SUBJECT: HYDROLOGIC ENGINEERING SAFETY QUESTIONS FOR VOGTLE
OL REVIEW

Plant Name: Vogtle Electric Generating Plant
Licensing Stage: OL
Docket No. 50-524/525

Review Comments - VOGTLE FSAR

TYPICAL GEOLOGIC CONDITIONS

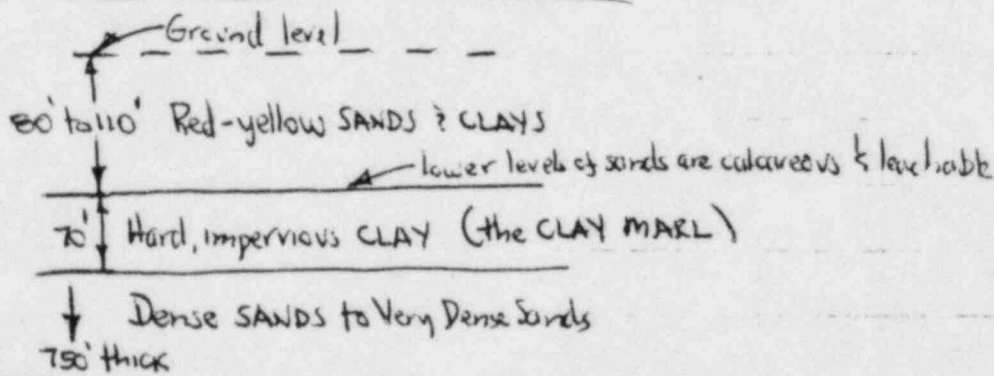
R. 1.2.1-2 Evidence of solutioning due to leaching of calcareous sands by local near-surface SUBSIDENCE. Solutioning stated to be in materials ABOVE structure's bearing layer

Settlement of Structures on Cat. 1 Backfill (sand & silty sands)

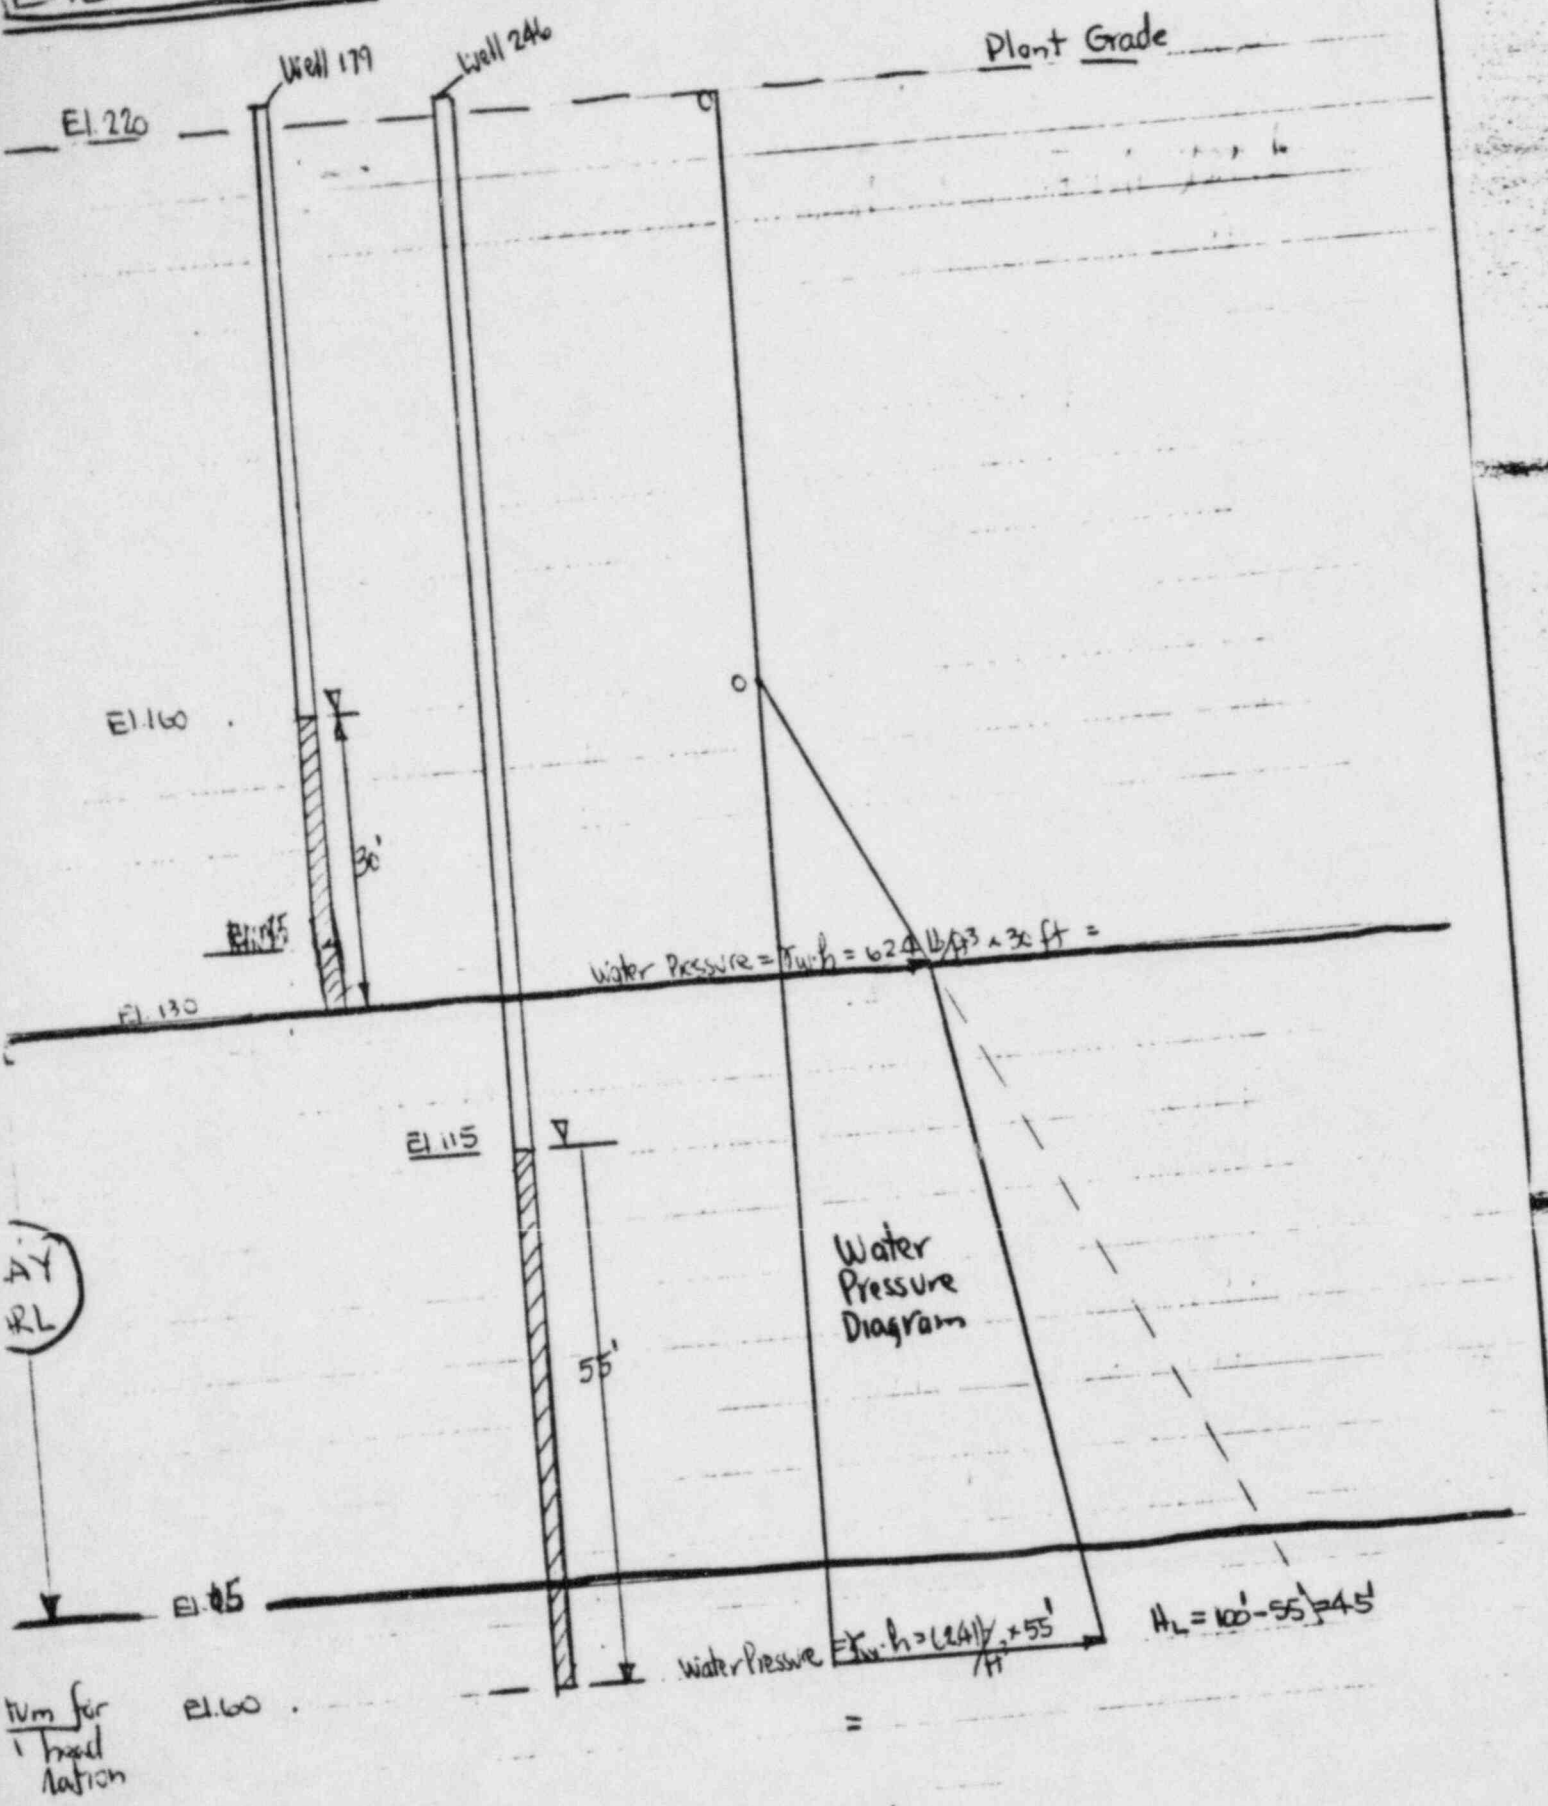
Estimated only "immediate settlements" (not consolidation settlements) for structures on Cat. 1 Backfill

Soil Parameters used for Cat. 1 backfill

$\gamma_m = 120 \text{ pcf}$, $\gamma_{\text{sat}} = 130 \text{ pcf}$, Poisson's ratio = 0.4, $E_s = 1500 \text{ ksf}$
